**Statement of Compliance  
Access for People with a Disability**

**Proposed Residential  
Development**

28-32 Evan St Penrith

**Report Type:** Statement of Compliance - BCA Access Provisions  
**Development:** 28-32 Evan St Penrith

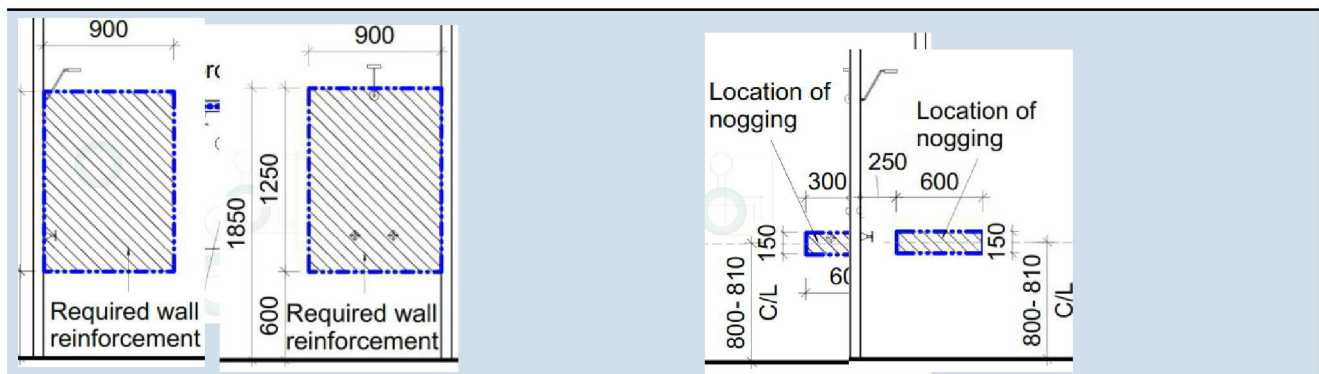
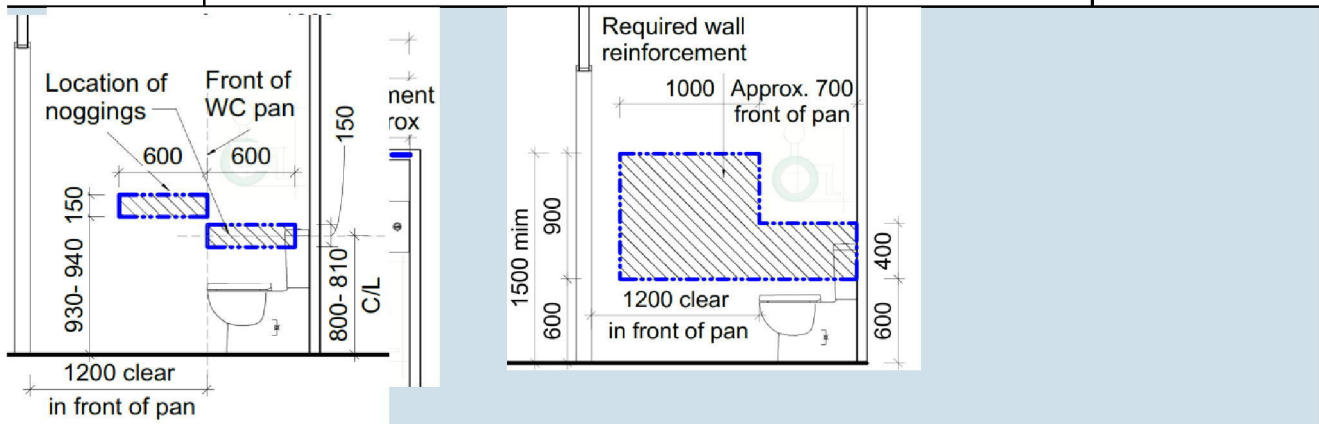
In addition to the adaptable units provided the following 6 units **107, 110, 207, 210, 307 & 310** are capable of providing compliance with the features of Silver level of Livable Housing Guidelines as noted in the table below.
